**BOONE COUNTY, MISSOURI**  
**Request for Bid #: 23-26APR12 – Coliseum Light Fixture Replacement**

**ADDENDUM #1 - Issued April 20, 2012**

# GENERAL MISSOURI EVENTS CENTER

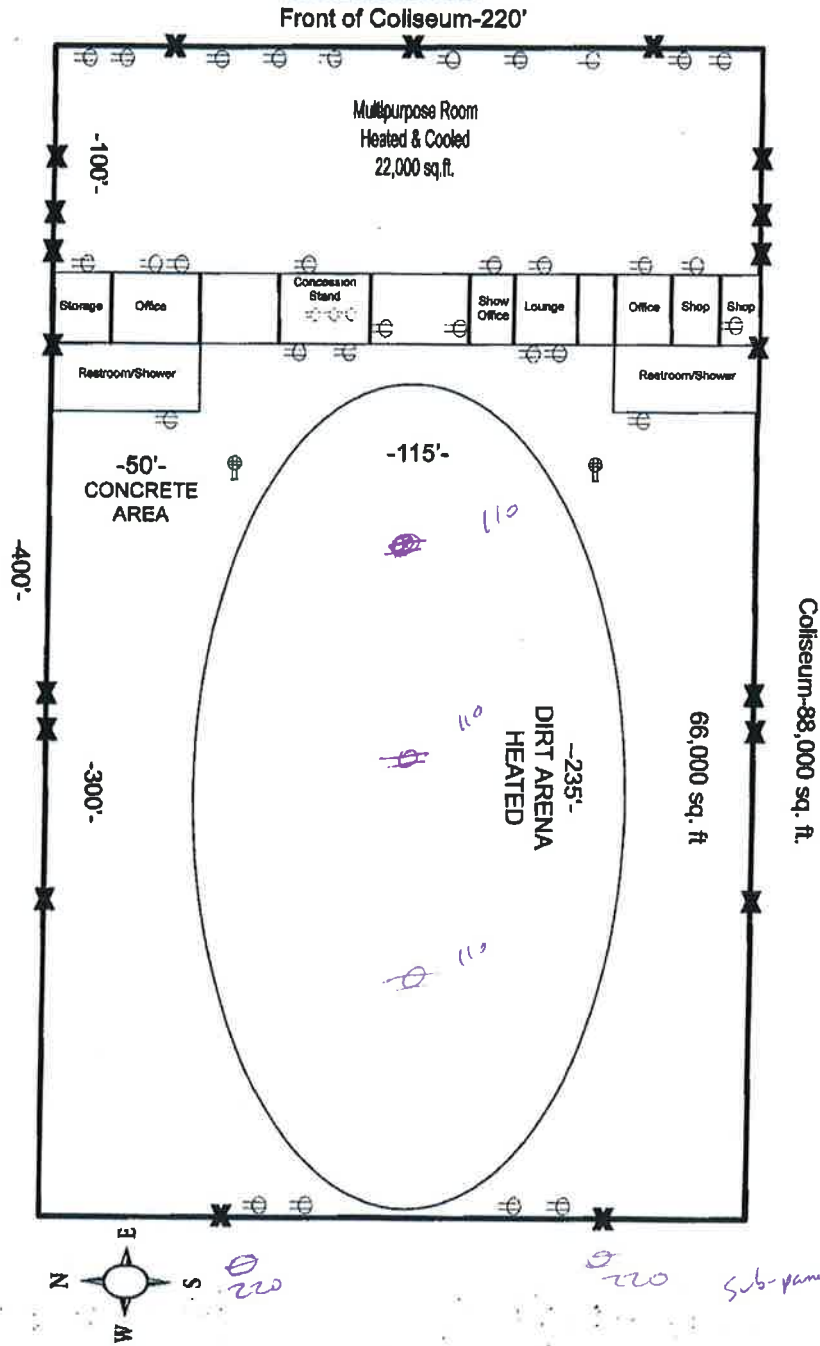
3. Replace the Bid Form with the Revised Bid Form. This form adds pricing for 39 electrical outlets as identified in the attached drawing *Central Missouri Events Center* as Option 2 and one 200 amp sub-panel on the west wall with (2) 220 volt outlets on either side of the over-head door.
